ADDENDUM No. 3

Project	T.A. Blakelock H.S. Renovations - Phase 1	Project No.	2215A
Location	1160 Rebecca Street, Oakville, Ontario	Date of Issue	2023 03 31
Owner	Halton District School Board	File	2215/7.1.3

This Addendum forms part of the Contract Documents and amends the original Drawings and Specifications, dated 2023 03 16, as noted below.

1 LEVEL 0 - LEARNING COMMONS (S109), INNOVATION LABS (S107 & S108) AND TECH DESIGN LABS (S110 & S111) RENO PLAN
A201 1:100

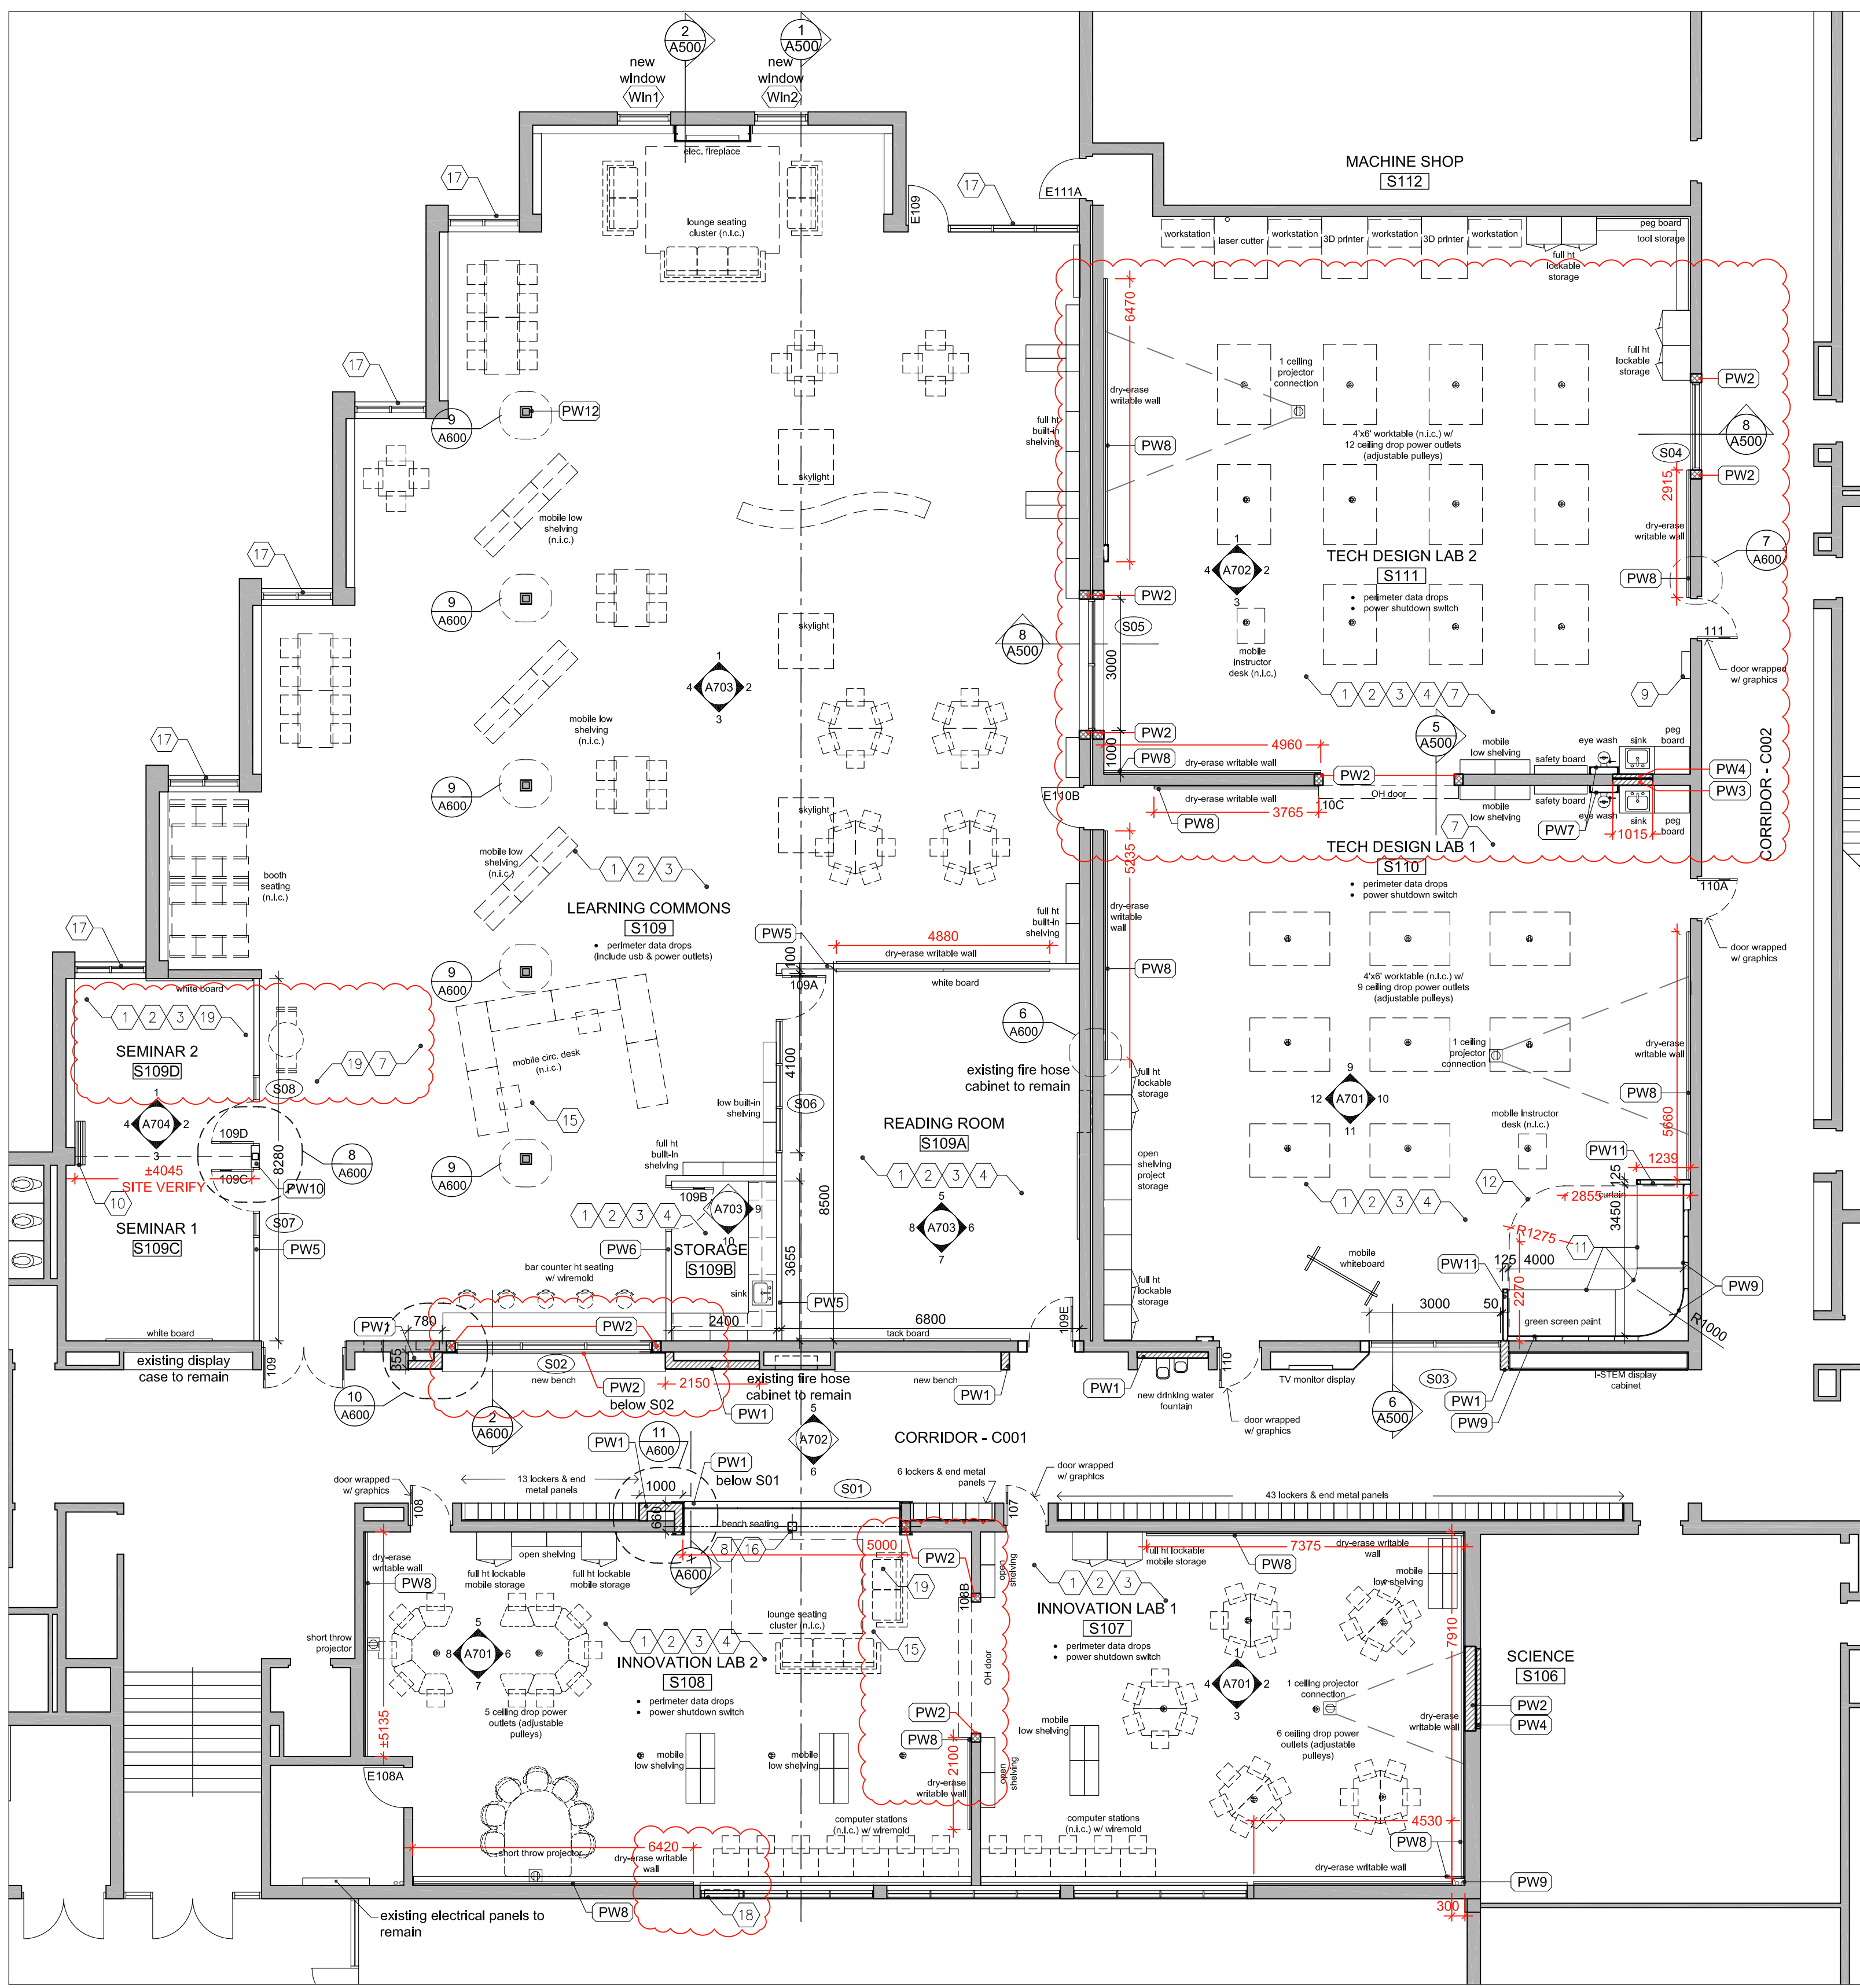
A3-2 DRAWING NO. A201 LEVEL 0 RENOVATION PLANS (reissued)

.1 Replace drawing with the attached Revision No. 2, dated 2023 03 31.

.2 Revisions include:

- .1 Revised Renovation Notes No. 12 and 17.
- .2 Added Renovation Notes No. 18 & 19.
- .3 Added Construction Notes No. 22 & 23.
- .4 Added Renovation Note tags No. 7 in Rooms S109, S110 & S111.
- .5 Additional dimensions and wall tags in red.

Q1: Drawing A201, Rm S110, you show a curved wall with a 1000mm radius. According to the gypsum association the max radius for the drywall is 4600mm, so to obtain the smooth curve you are looking for another material would need to be used.

A1: Wall curves to be achieved with the use of “*Cyclorama Trim: High impact ABS plastic fabrications with tapered edges, consisting of floor cove modules and corner modules; 1067 mm radius; System 3EZ by Pro Cyc, Inc.*” Refer to Project Manual for details.

10 PLAN DETAIL @ S02 IN S109
 A600 1:10

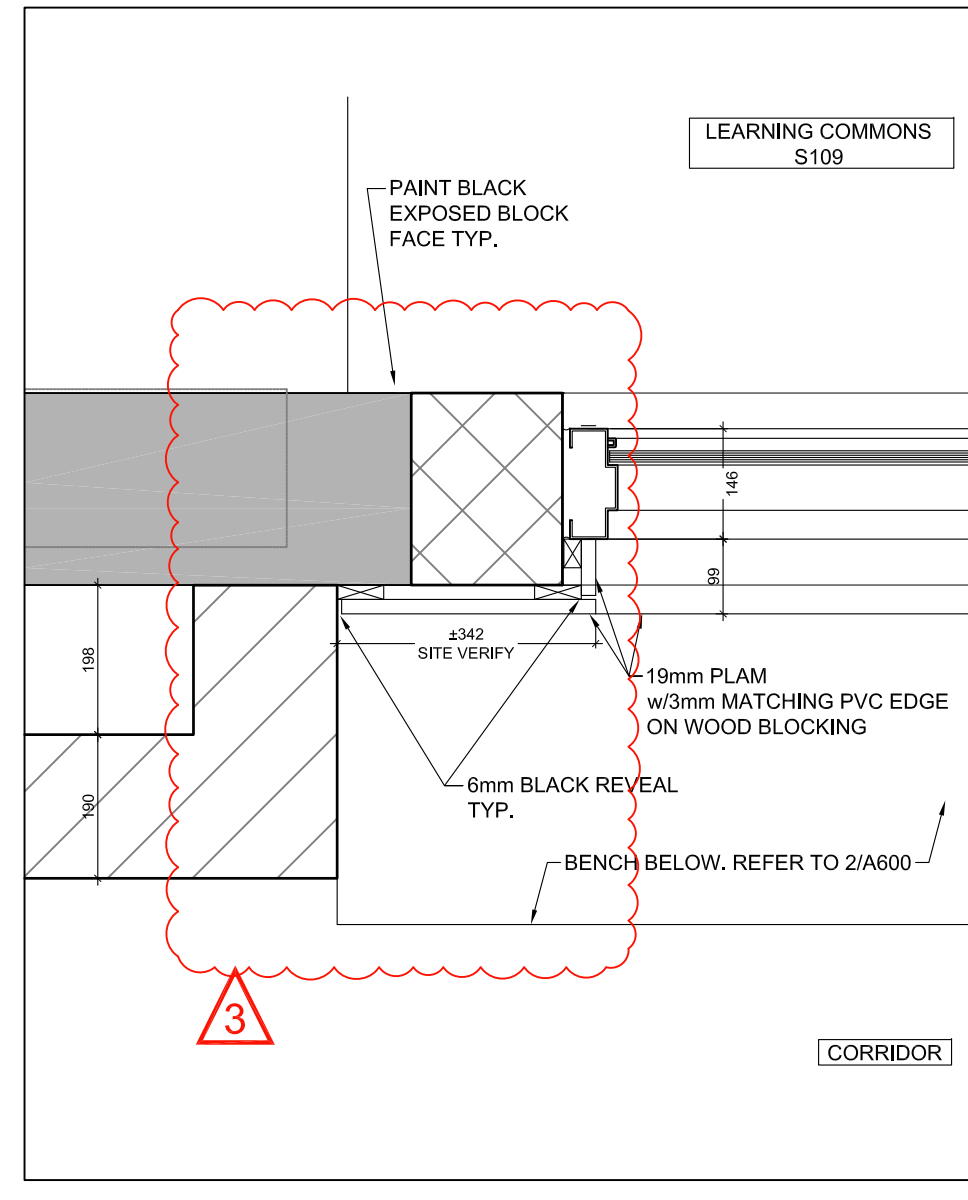
- .1 Replace drawing with the attached Revision No. 3, dated 2023 03 31.
- .2 Replace "19mm Plam" with "19mm Plam w/ 3mm matching PVC edge".
- .3 Revise Details No. 2 and 10 for Plam scope at Screen "S02".
- .4 Add Detail No. 13.
